UNITED STATES  
NUCLEAR REGULATORY COMMISSION  
REGION III  
799 ROOSEVELT ROAD  
GLEN ELLYN, ILLINOIS 60137

Re: LETTER DATED JULY 27, 1984 FOR RENEWAL OF NRC LICENSE NUMBER 14-18649-01,  
CONTROL NO. 77188

ELEVATION CC

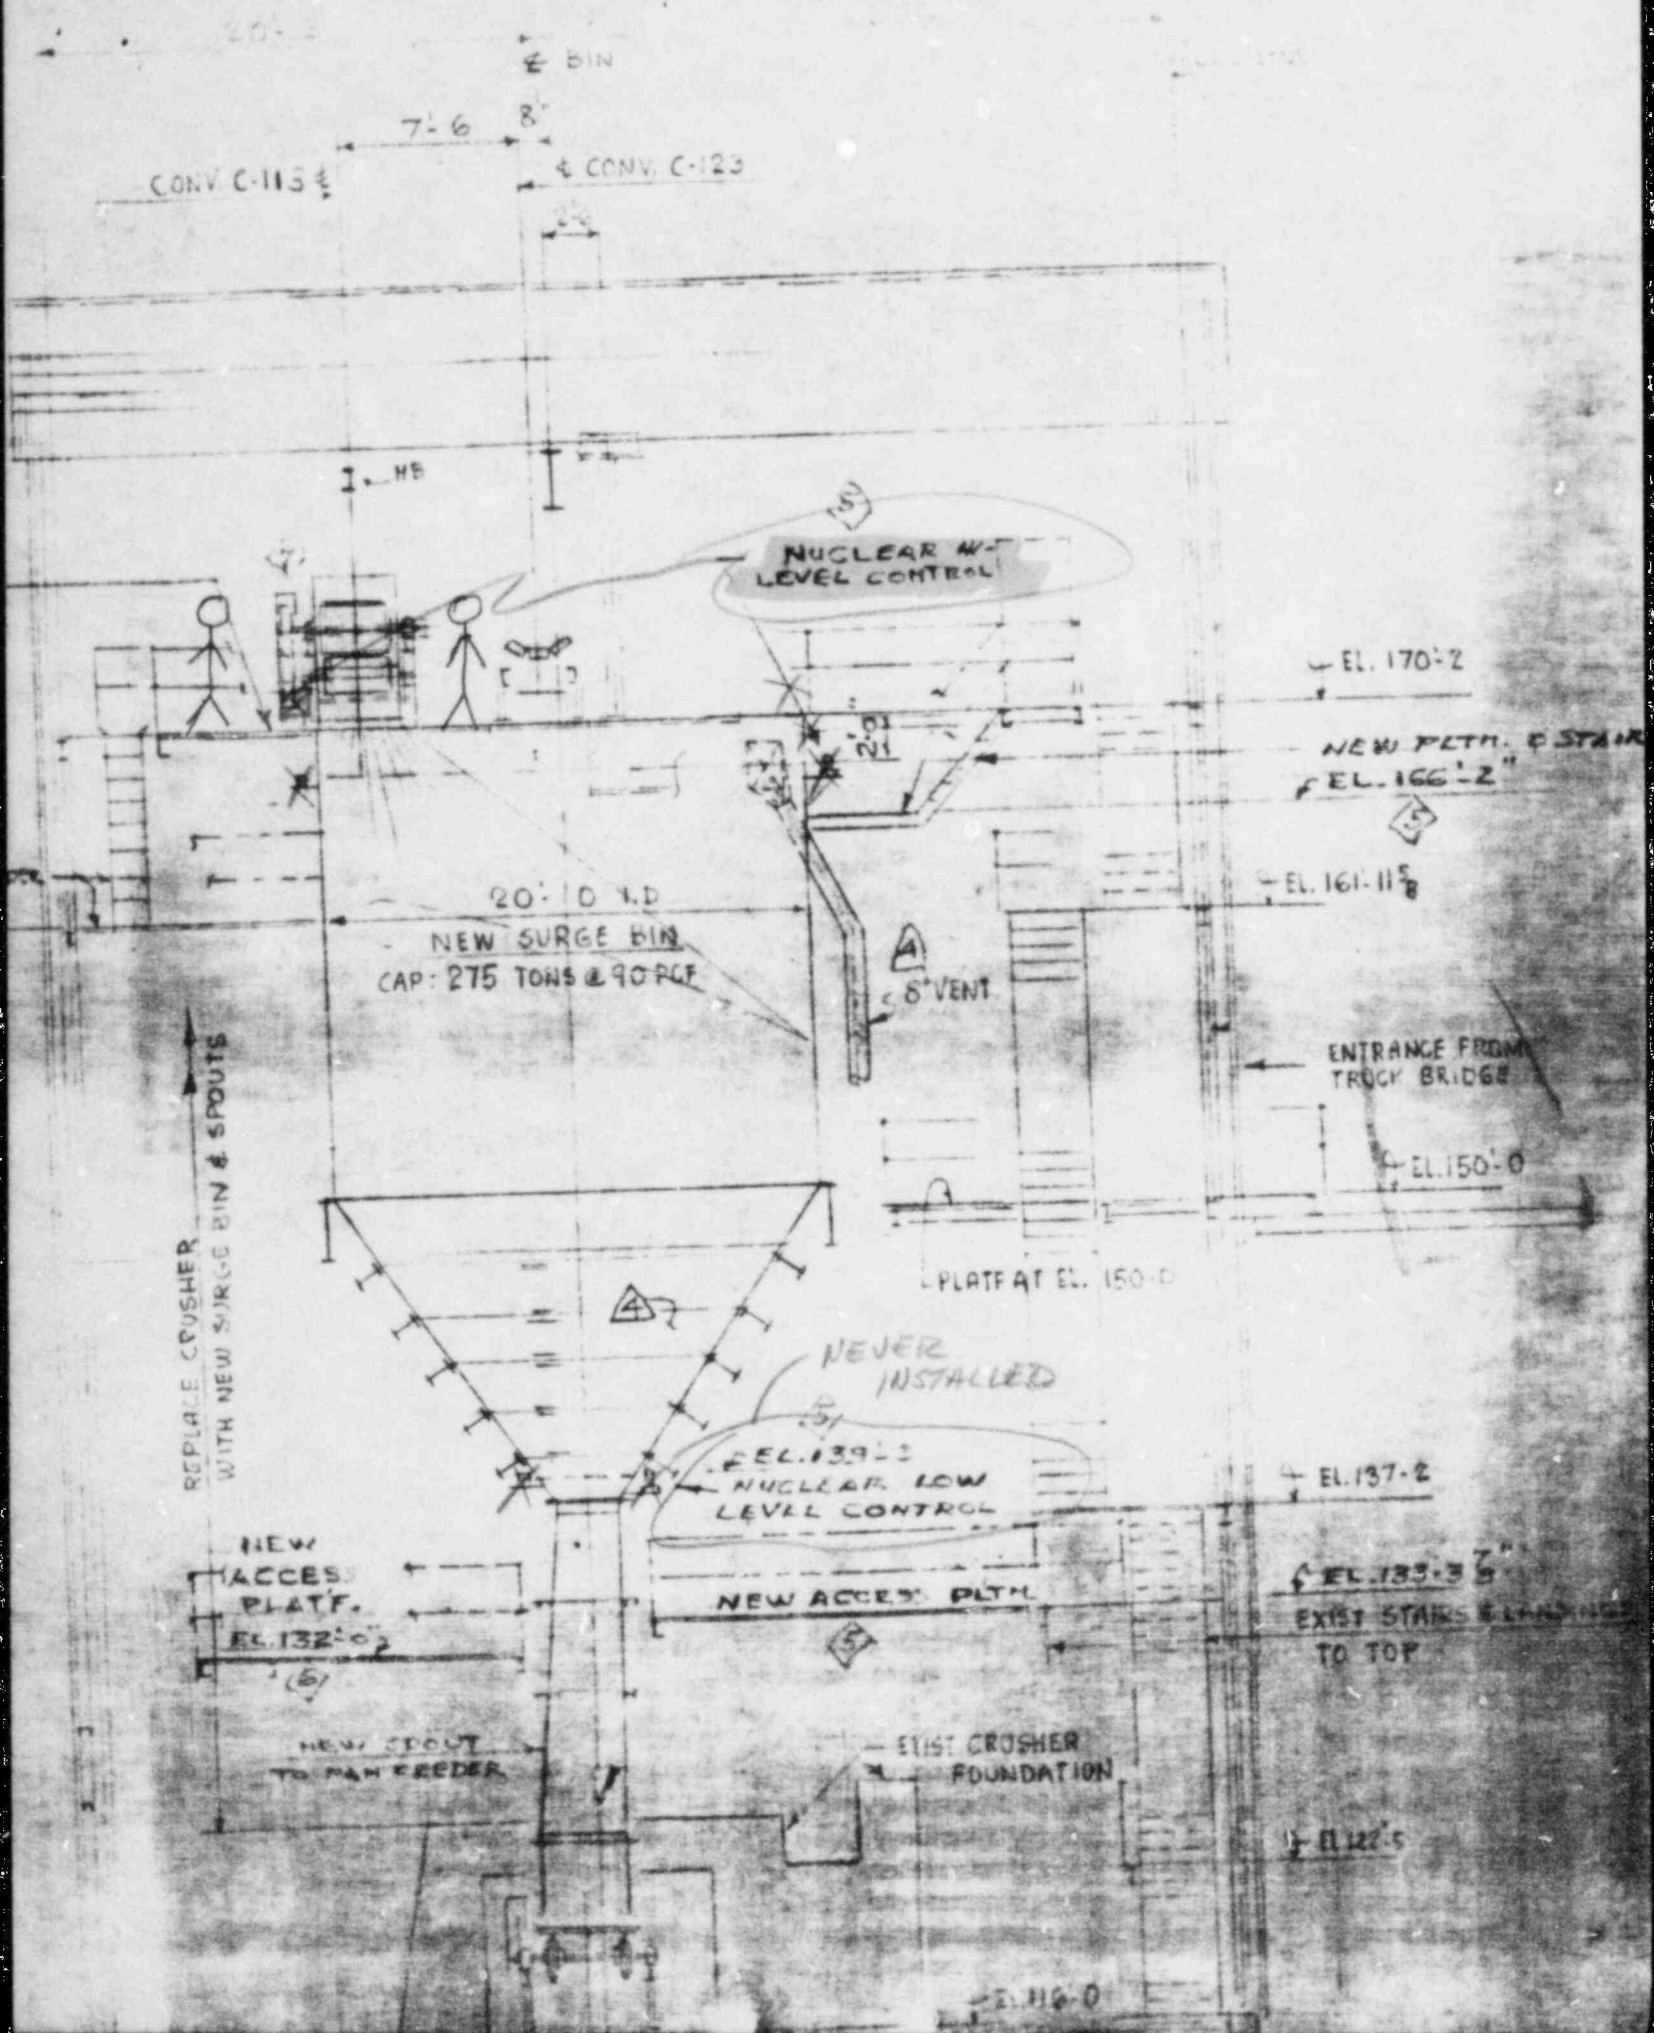
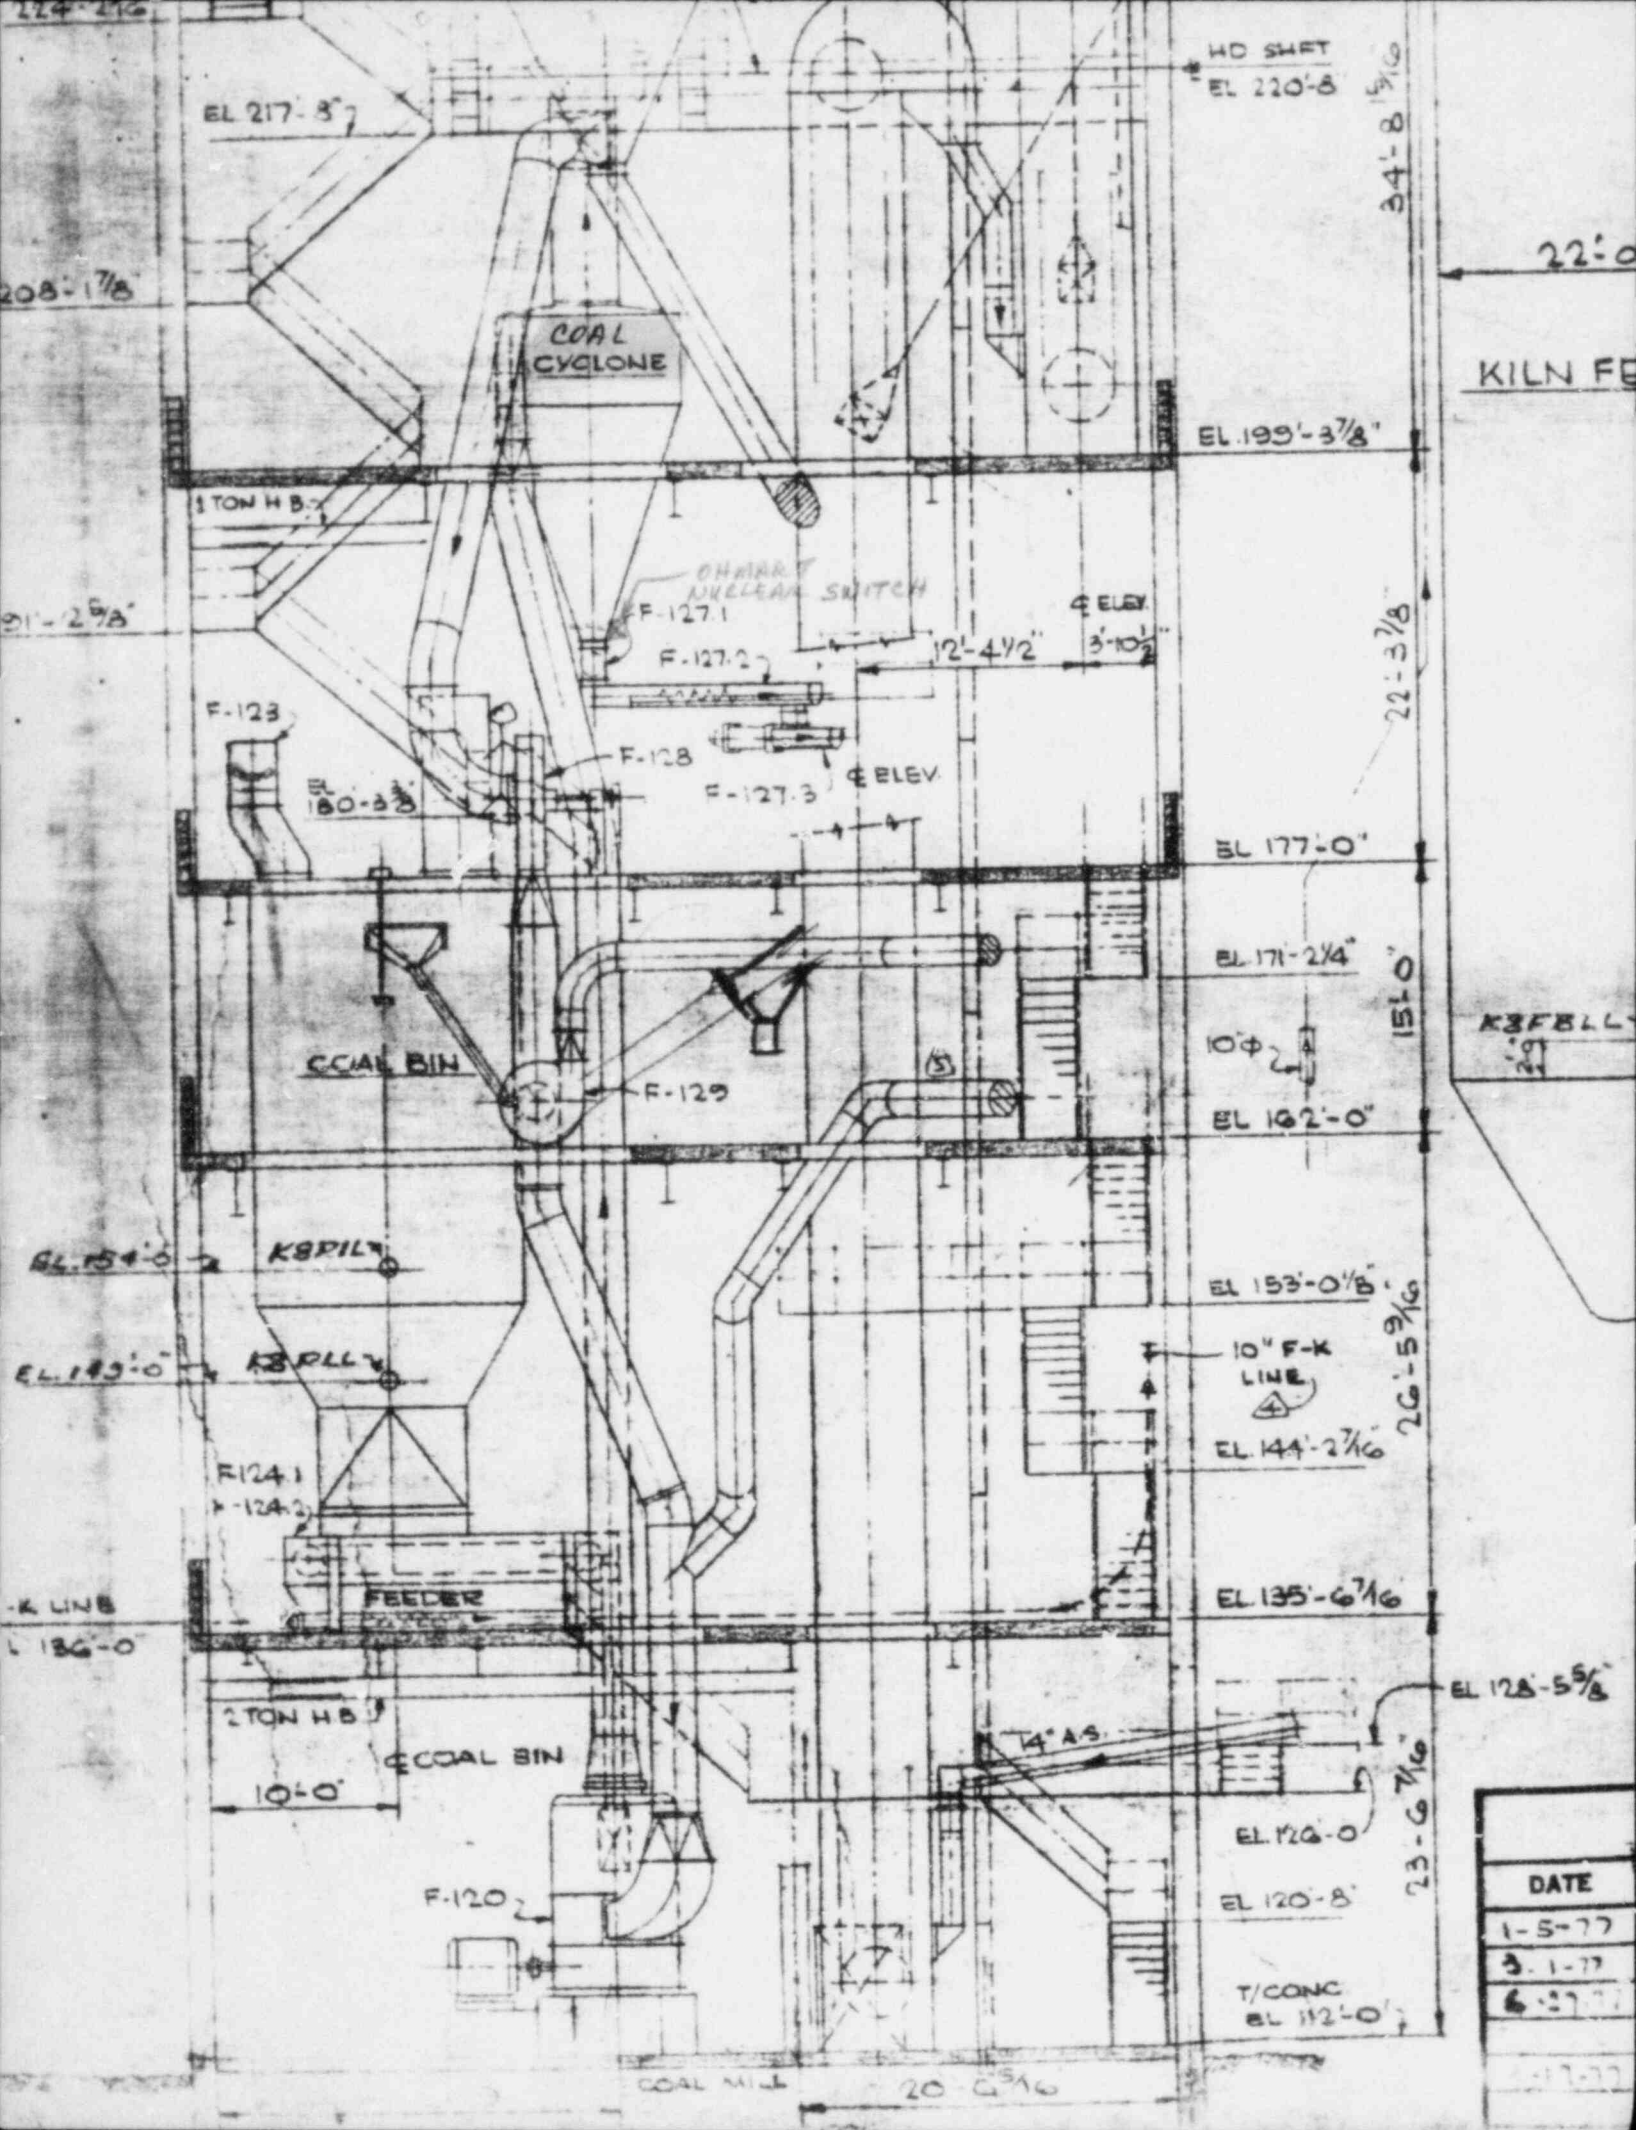
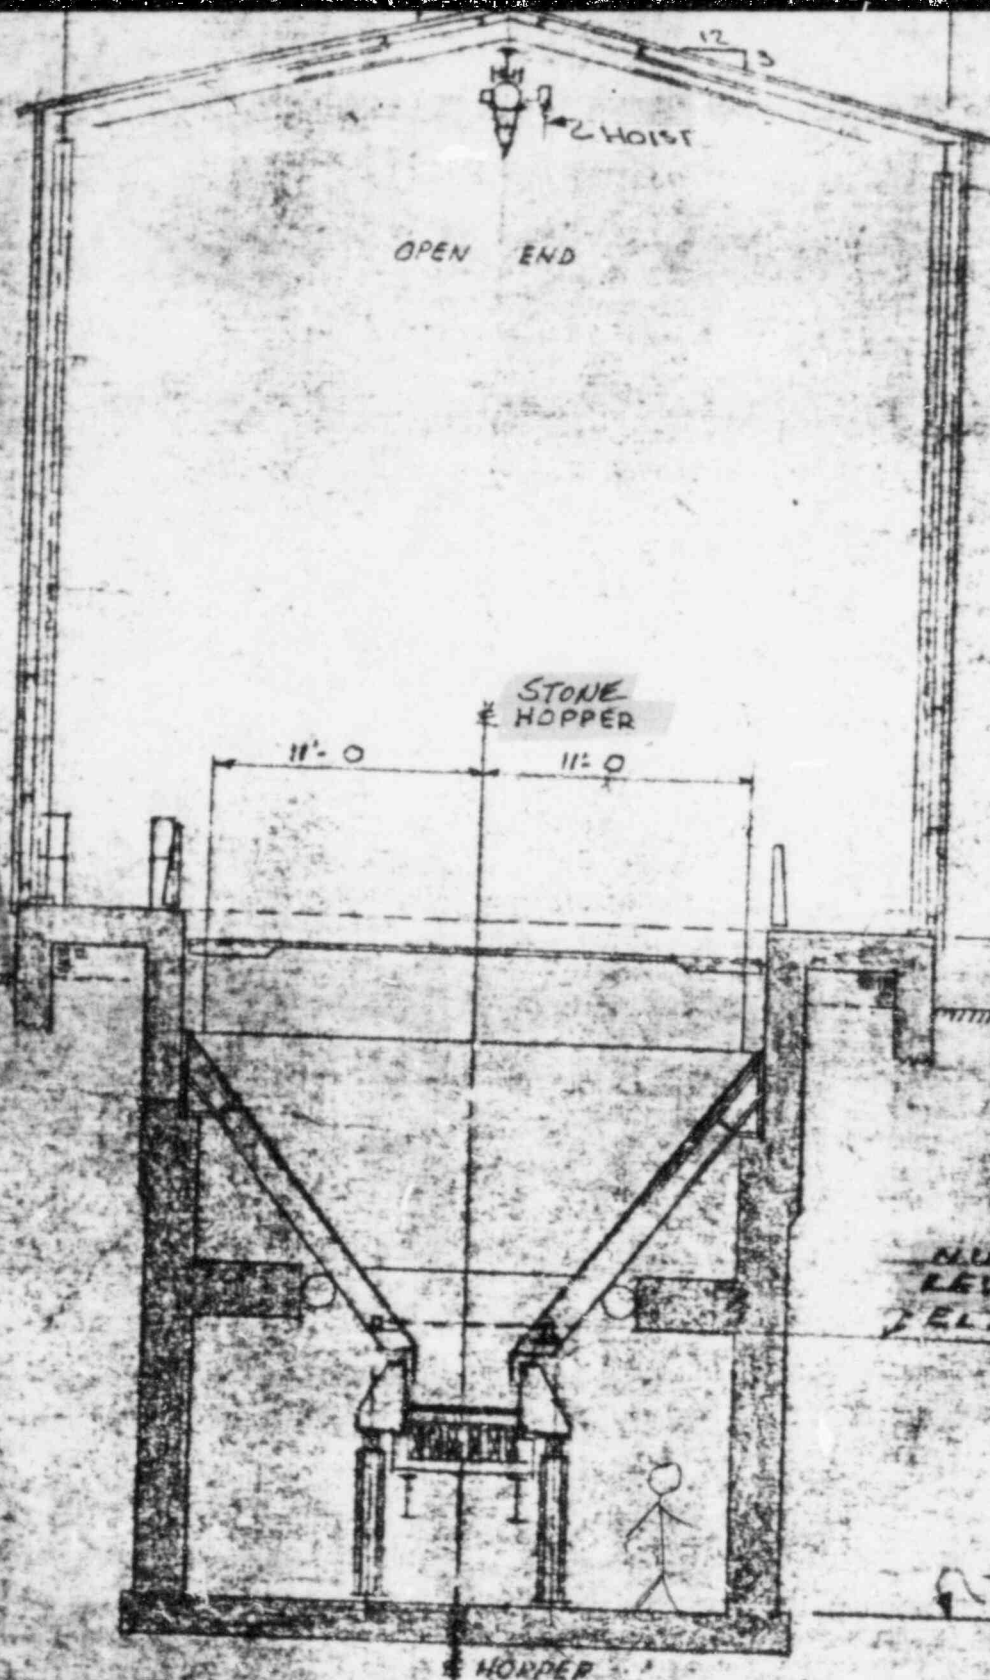
2. Please specify the model number of the leak test kit and the supplier of the leak test kit.
3. Please submit a simple annotated sketch or drawing showing where each gauge is installed and the location of adjacent ladders, aisles, or work areas employees will occupy.

*ry + 3 gauges located outside accessible work area*
